OUR REF: 5941
YOUR REF: MIN/2019/761

RE: REQUEST TO MAKE A MINOR CHANGE APPLICATION TO DEVELOPMENT PERMIT FOR RECONFIGURING A LOT (1 INTO 38 INDUSTRIAL LOTS, STORMWATER DETENTION LOT, NEW ROAD AND A BALANCE LOT), OPERATION WORK (CHANGE TO GROUND LEVEL) AND OPERATIONAL WORK (VEGETATION CLEARING)

AT: 60 STAPYLTON JACOBS WELL ROAD, 82 CHRISTENSEN ROAD AND 31 YELLOWWOOD ROAD, STAPYLTON QLD 4207 (LOT 500 AND 501 ON SP295994 AND LOT 4 ON RP6843 (FORMALLY LOT 1 ON RP6882, LOT 240 ON W31320 & LOT 4 ON RP6843))

We act on behalf of the Applicant, Frasers Property Pty Ltd, and provide the following response to Council's Information Request emailed 3 February 2020. The Applicant considers this a partial response to the information requested, and requests Council to proceed with their assessment of the development application.

Figure 1: 3D render of proposed batter and landscape buffer (GDP File, 2020)

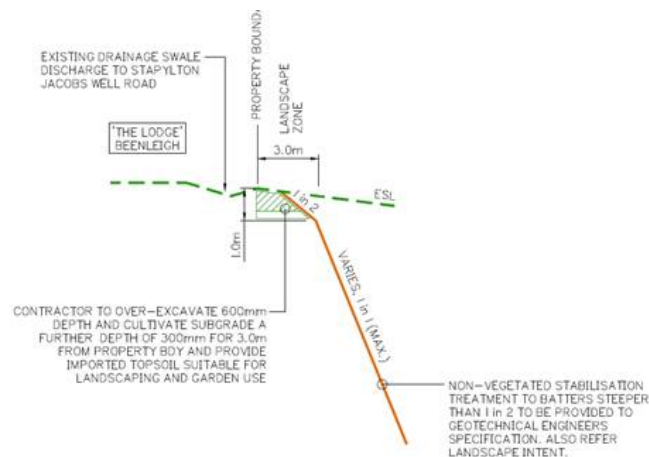
A review of the bulk earthworks plans, specifically Dwg no. 5941 ENG BE1 151 Rev. A, has identified that earthworks are proposed within the 3 metre planting area of the 10 metre landscape buffer along the western boundary. The applicant has identified throughout the bulk earthworks plans that the soil within the 3 metre buffer will be cultivated. While cultivation of soil within this buffer is supported, the presence of a batter within this 3 metre planter buffer is not supported. The applicant is therefore requested to amend the bulk earthworks drawings package to reflect that the entire 3 metres of the buffer is able to support the necessary planting and will not involve batters; especially not batters 1V:2H or steeper which officers have already identified as requiring non-vegetated stabilisation treatments. To assist in demonstrating this requirement, the applicant is requested to provide detailed sections through the rear of each of the lots

adjoining the western boundary (proposed lots 101-110) that clearly demonstrate the 3 metre planting buffer free of batters.

DETAIL A – TYPICAL TOP OF CUT BATTER TREATMENT AT NEIGHBOURING RESIDENTIAL DEVELOPMENT INTERFACE

In response to this item raised by Council, namely the concern with having a 1:2 batter within the landscape buffer, it is important to note this batter reflects a geotechnical stability requirement to achieve a suitable soil stability outcome in this location that will ensure longevity of the batter and landscape buffer. As reflected within the Negotiated Decision Notice issued by Council on 1 March 2019, only planting on batters steeper than 1:2 is restricted through conditions. As this small section of batter does not exceed 1:2, planting can be undertaken. Further, the remaining two metres of the landscape buffer provides ample opportunity to deliver deep planting in accordance with the relevant landscape intent plan that will establish a well vegetated landscape buffer.

In regard to Council's request for individual lot sections, this amount of sectional drawings is not considered necessary in this instance. Rather, the Applicant has provided a 3D section of the steepest section of batter to demonstrate how a suitable landscape batter will be achieved (**Figure 1**).

In this respect, it has been determined that no changes will be made to the design of this batter or relevant landscape buffer.
